Highgate Conservation Area Advisory Committee

2 MAY 2023 HGY/2023/0328: DYNE HOUSE PLANNING APPLICATION

Highgate Conservation Area Advisory Committee objects to HGY/2023/0328, Dyne House planning application.

A_HS-DHS-2521_J_230113_East and West Proposed elevations [see top left drawing for front elevation]

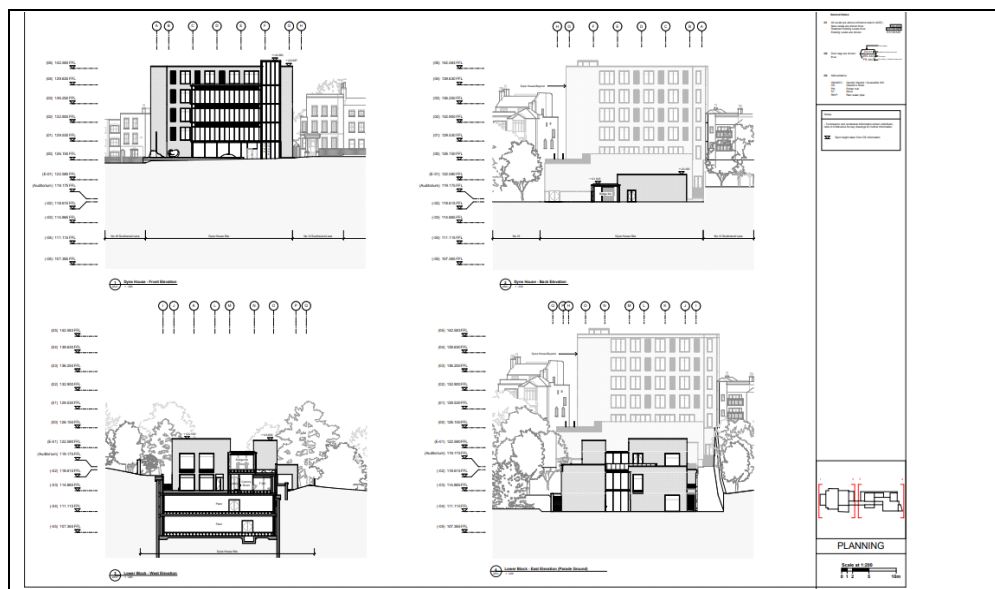
The CGI on the previous page shows a simplified rendition of the elevation of no. 16 Southwood Lane. This house is unusual for the period because it barely has the normal hierarchy of storey heights and the proportions of the windows. We note that there is one course fewer to the second floor window than to the first floor window. Our photograph of the rest of the terrace has the usual hierarchy, that is, houses of that period have taller first floor windows than the top floor and generally slightly taller than the ground floor windows. The first floor windows reflect the status of the rooms and their taller ceiling heights.

The endeavour to make Dyne House appear to be more like its neighbours and 'fit in' to the street scene is dubious aesthetically and fails to achieve a result which overcomes the criticism of Dyne House in the Highgate Conservation Area Character Appraisal. However HCAAC must point out:

- The top floor of the existing building is set back from the front and rear facades and the roof is at 142,563
- The proposed roof is shown marginally higher not lower as claimed
- The height of the building is unrealistic taking into account: ceiling plenum; depth of ceiling/roof structure, depth of insulation, depth of green roof, height of parapet, plant on roof and safety railings.
